The following amendment 002 to the Request for Proposal (RFP) is raised to answer questions from the Industry:

RM148D

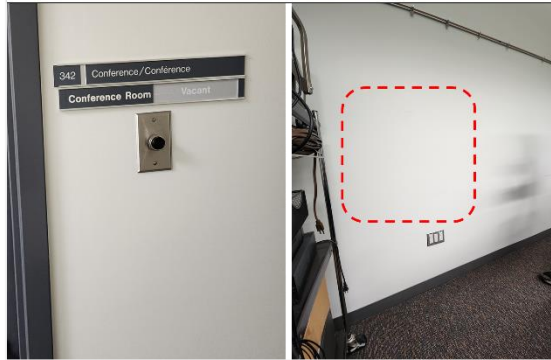
In review of the RFP 1.3.5.2 stipulates fibre backbone has already been installed, however, 1.4.2.2 is requesting additional fibre runs.

Please confirm the intent to supply new fibre runs and patch panels as noted in 1.4.2.2 in addition to the backbone previously provided.

New fibre runs are required as follows to interconnect new relay racks onto the existing fibre backbone. Public Works (PW) has confirmed that cabling between floors can be run via panel space located in the stairwell space of the Traffic Building with drilling.

Start Location	End Location
Traffic Building Main Floor Relay Rack 1 (RR-1) No Existing Fibre Patch Panel	Traffic Building Main Floor RM148D (Server Room) No Existing Fibre Patch Panel
Traffic Building Third Floor Relay Rack 2 (RR-2) No Existing Fibre Patch Panel	Traffic Building Main Floor RM148D (Server Room) No Existing Fibre Patch Panel
Relay Rack 3 (RR-3) Commercial Building No Existing Fibre Patch Panel	Commercial Building Office Space Existing Fibre Patch Panel
Relay Rack 4 (RR-4) Tertiary Garage No Existing Fibre Patch Panel	Tertiary Garage Office Space (SE corner near WS-11) Existing Fibre Patch Panel
